# Roadway Plans\_V1.pdf Markup Summary

# CONSTRUCTION PLANS

CLEARWAY FILING NO. 2, LOT 5		TITLE SHEET	
PROJECT NO. 44-042A		DATE: 06-02-2022	
DESIGNED BY: DIM		SCALE: HORIZONTAL: N/A	
DRAWN BY: CLP		VERTICAL: N/A	
CHECKED BY: DIM		SHEET 1 OF 15	
TS01

**FULL SPECTRUM DETENTION SAND FILTER POND 1 SITE PLAN**

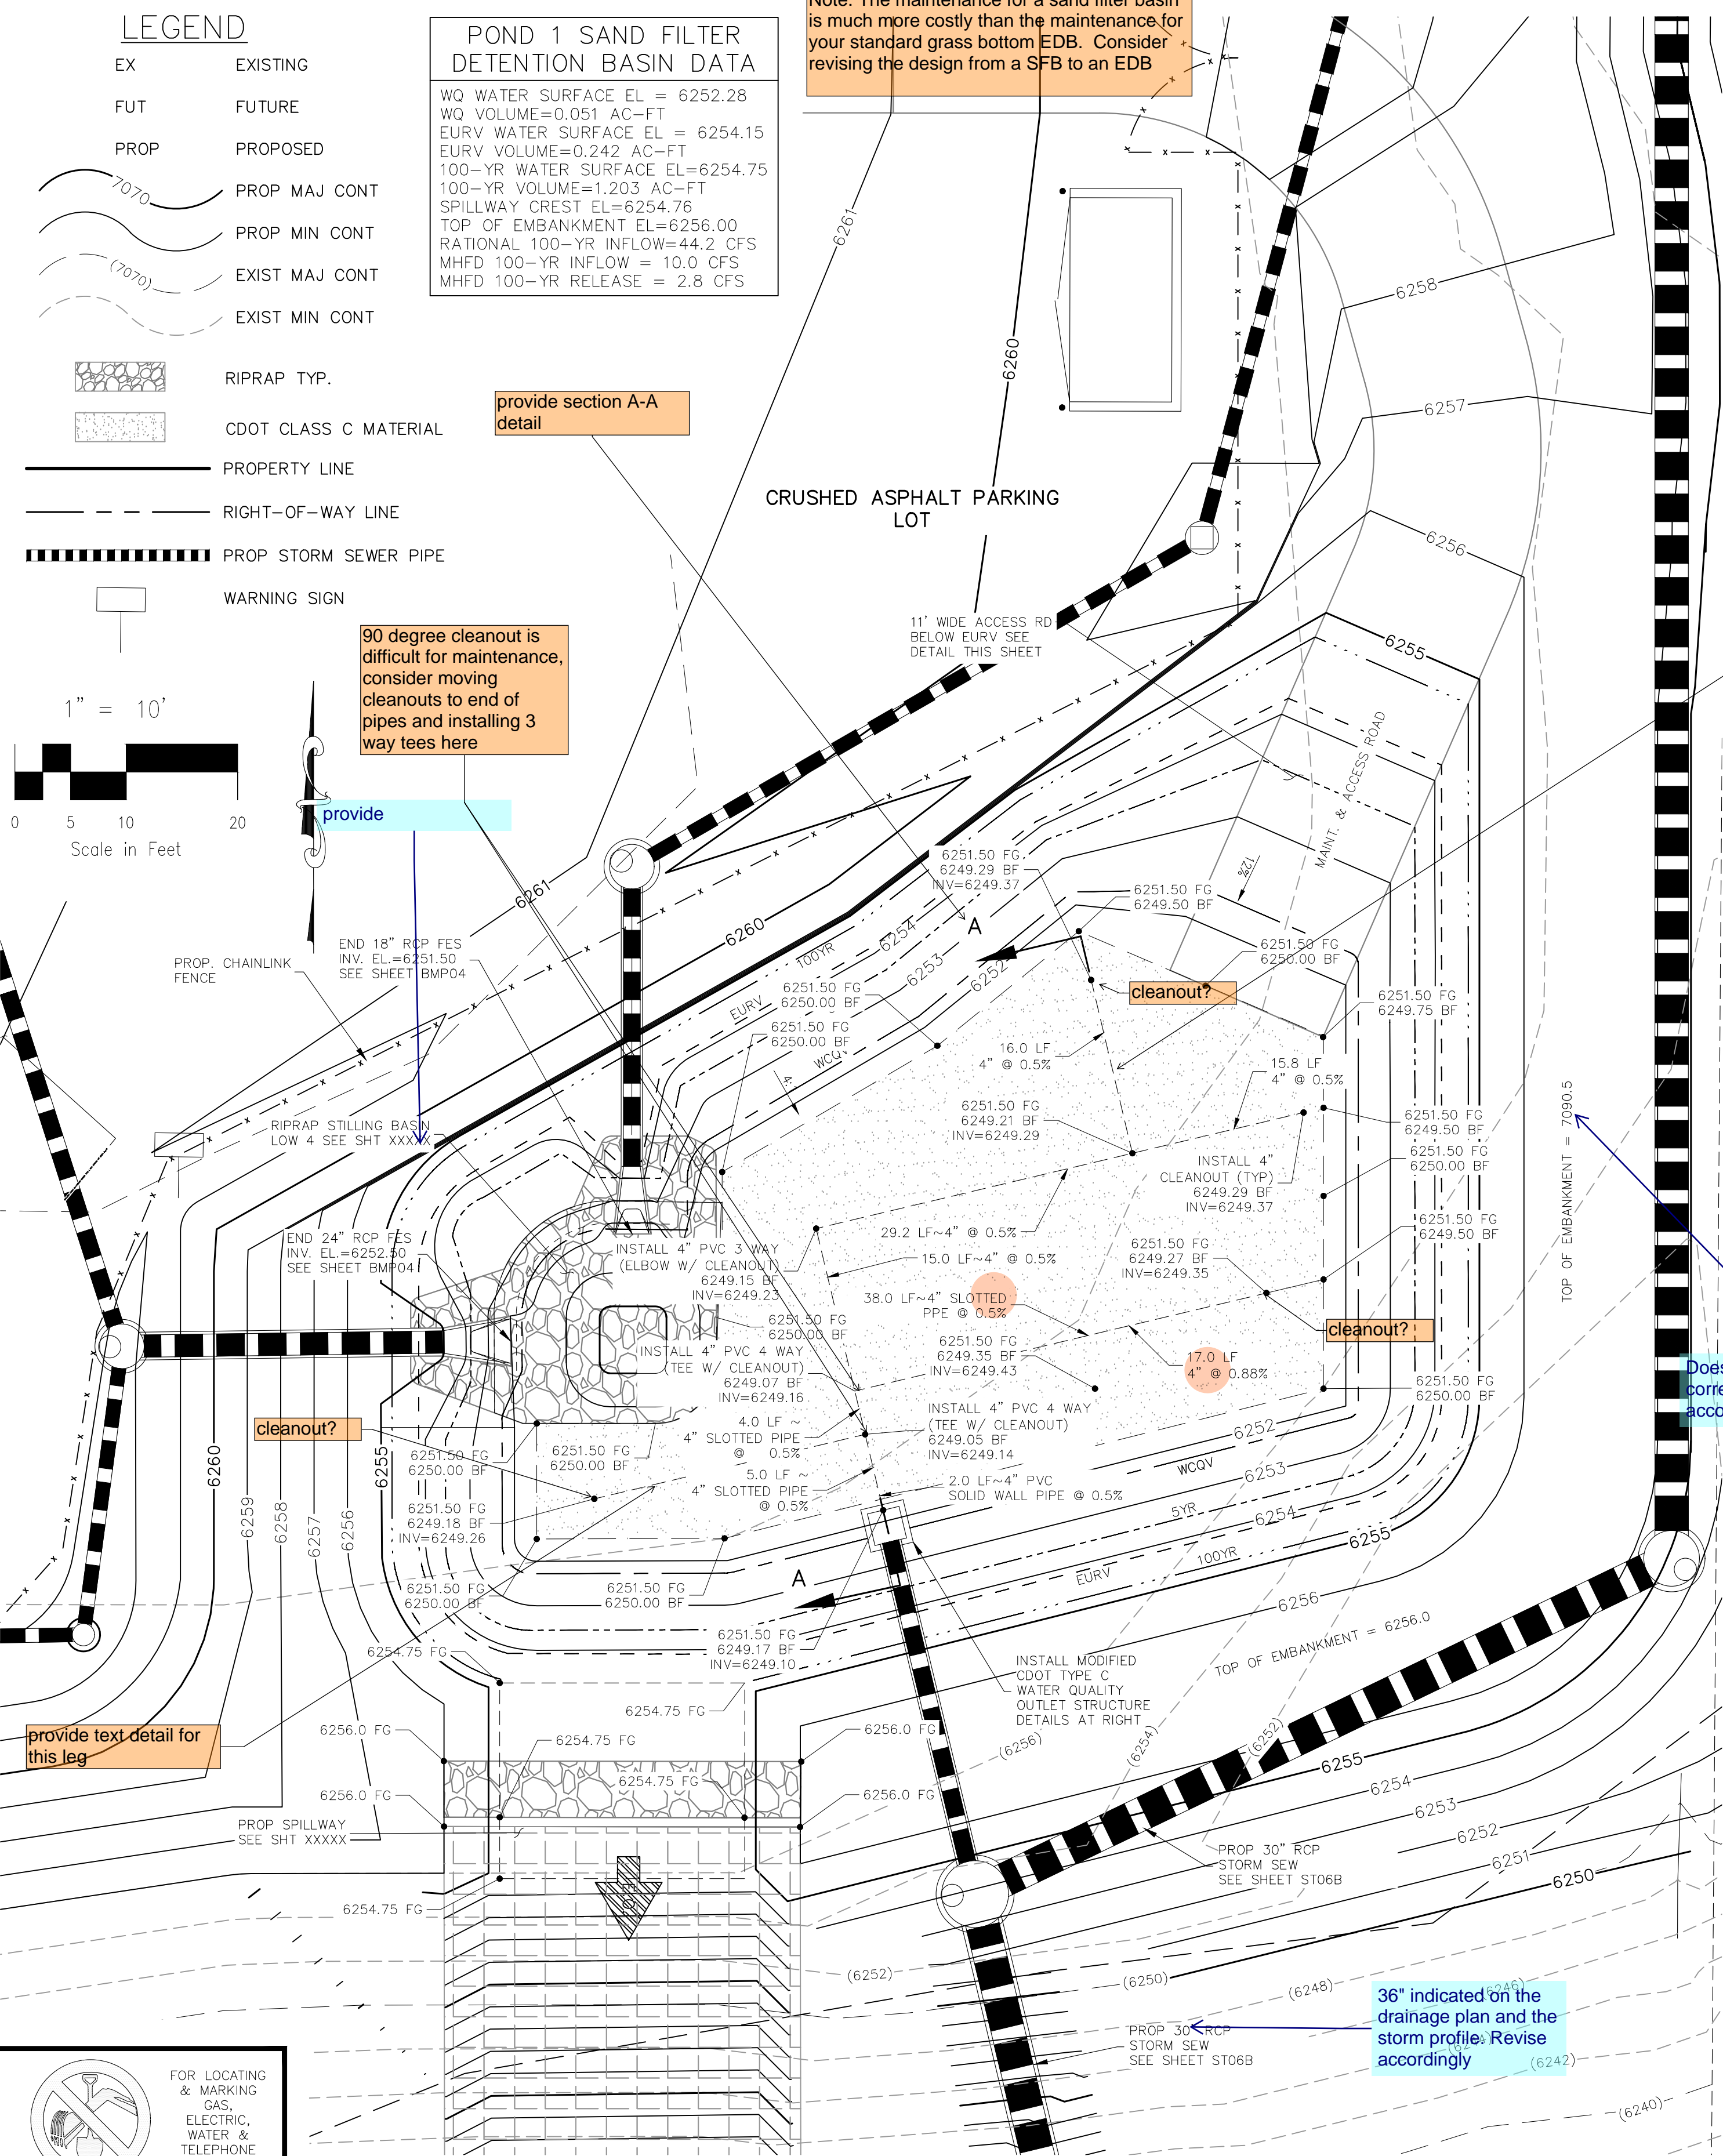
Note: The maintenance for a sand filter basin is much more costly than the maintenance for your standard grass bottom EDB. Consider revising the design from a SFB to an EDB

provide section A-A detail

provide

**MODIFIED CDOT TYPE C FULL SPECTRUM OUTLET BOX AND SAND FILTER SECTION A-A NOT TO SCALE**

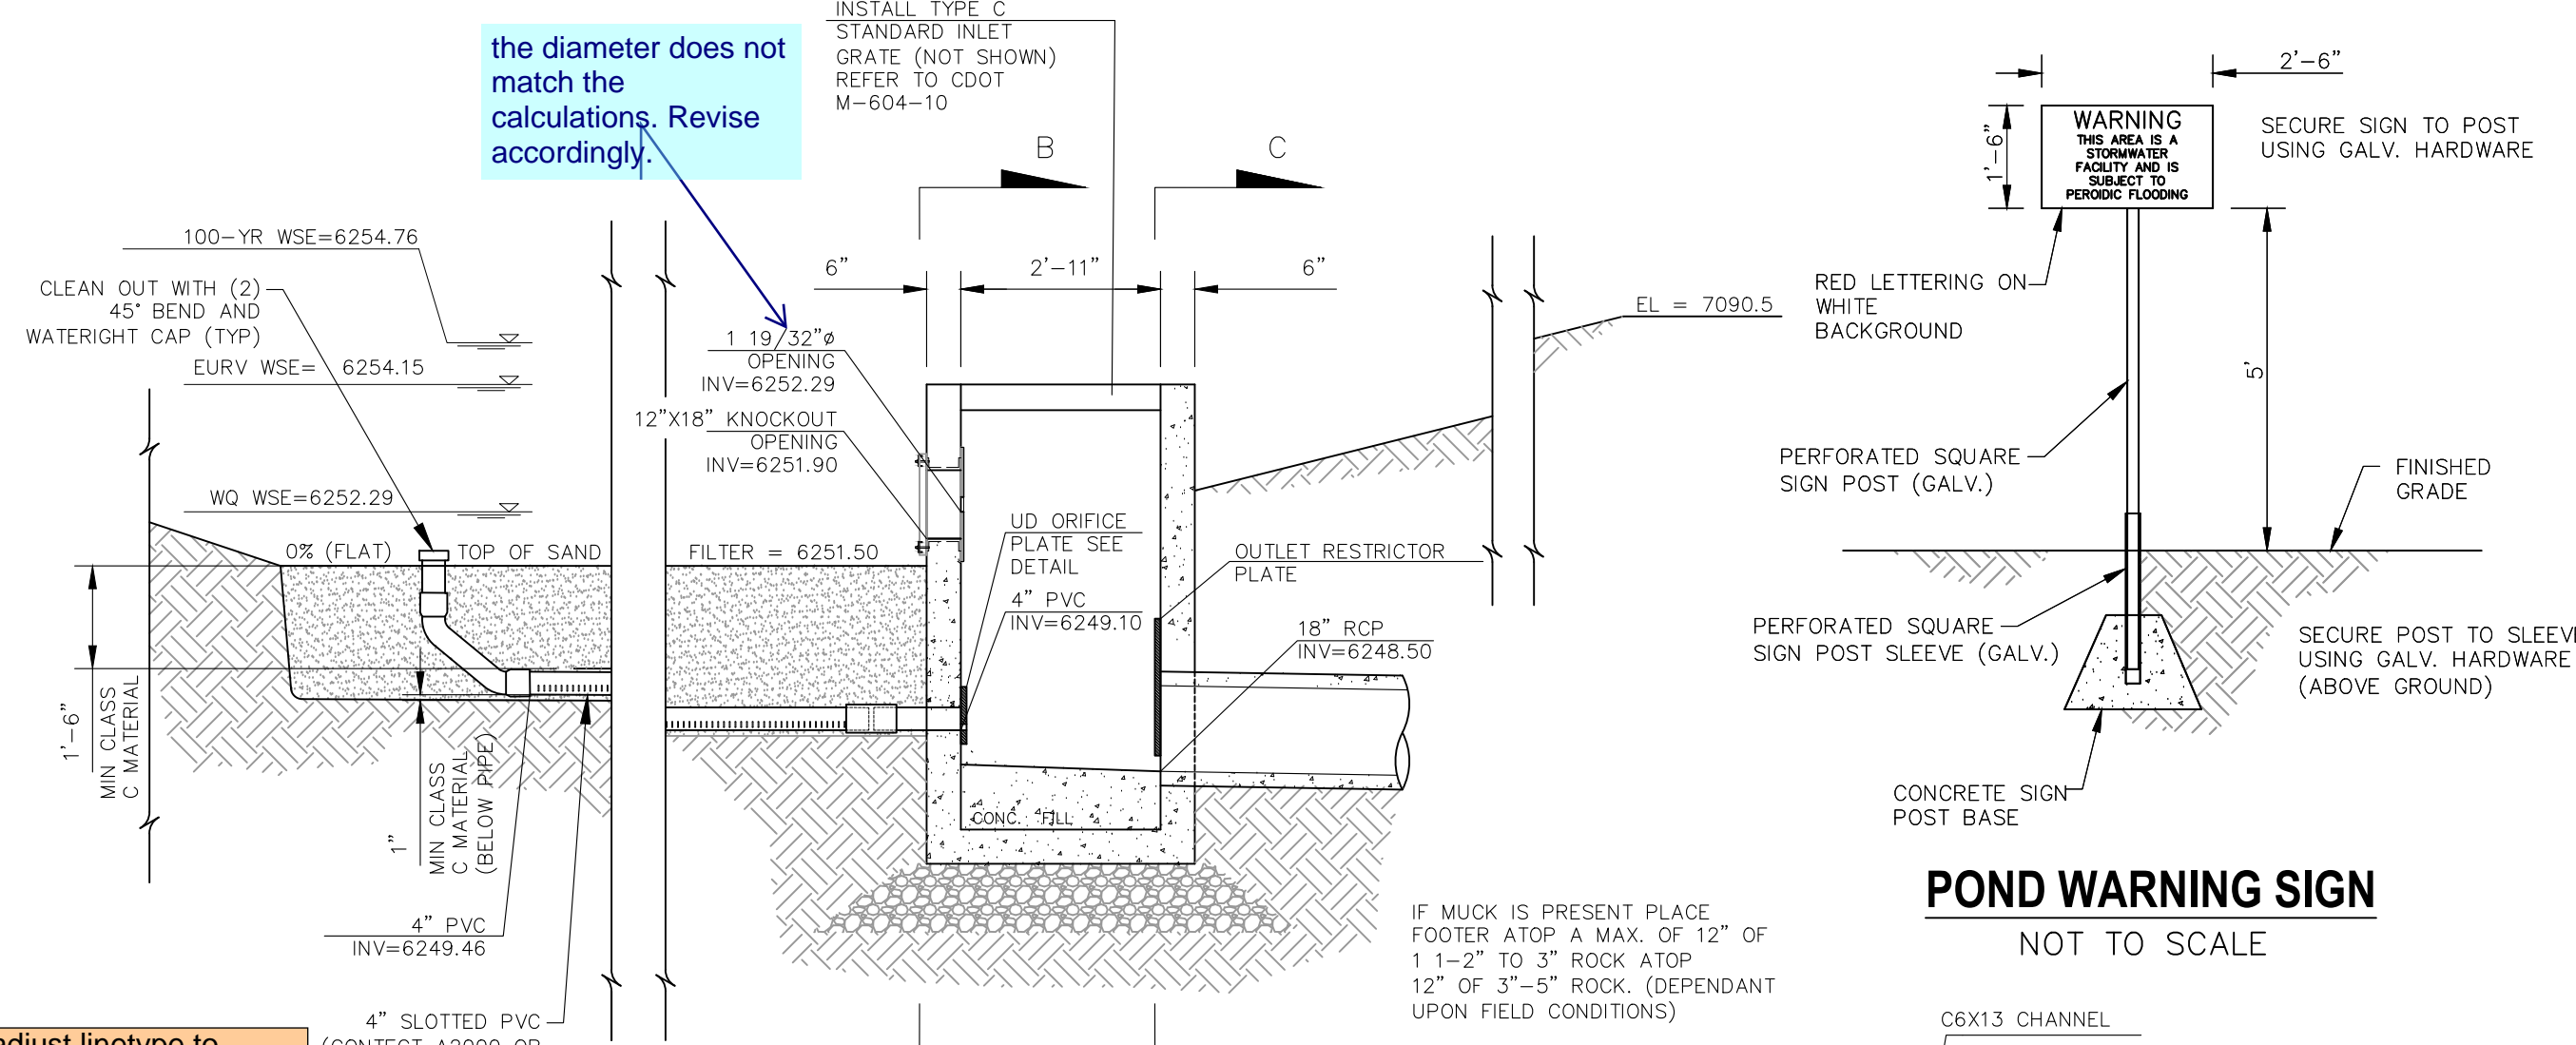
adjust linetype to clearly identify slotted PVC pipe locations

Amico 19-SR-2 INSTALL 27 3/4" X 18 3/4" AMICO STAINLESS STEEL BAR GRATE OR EQUIVALENT OVER OPENING, 3/16" WIDTH BARS ON 1-13/16" CENTERS CROSS RODS EVERY 2" ATOP 12"x18" OPENING IN CONCRETE

**MODIFIED CDOT TYPE C PLAN NOT TO SCALE**

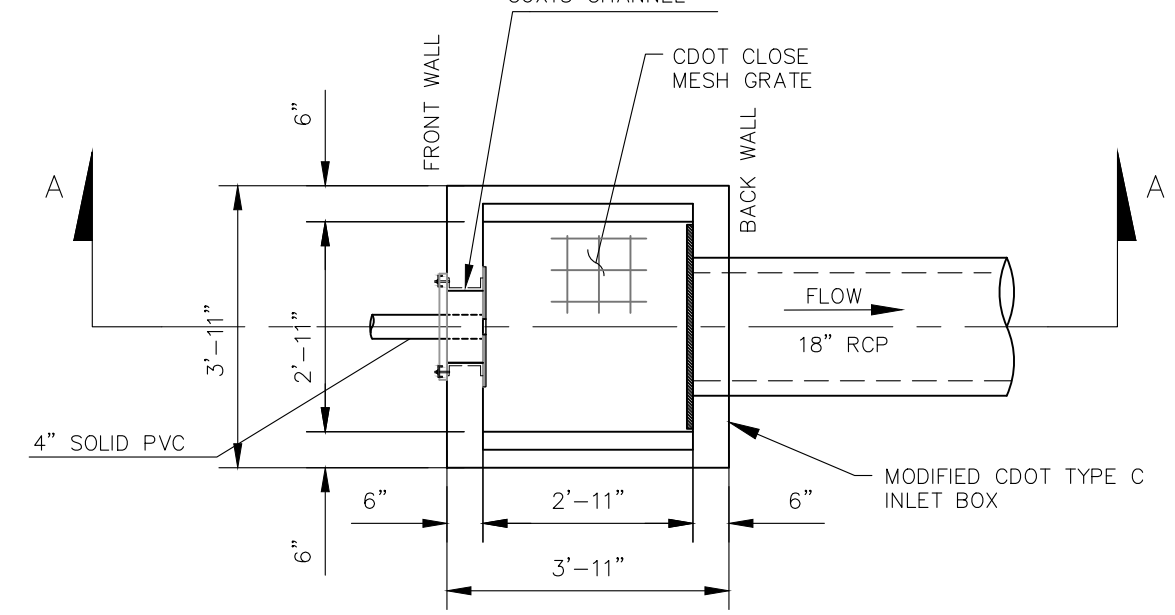
Does not appear correct, revise accordingly
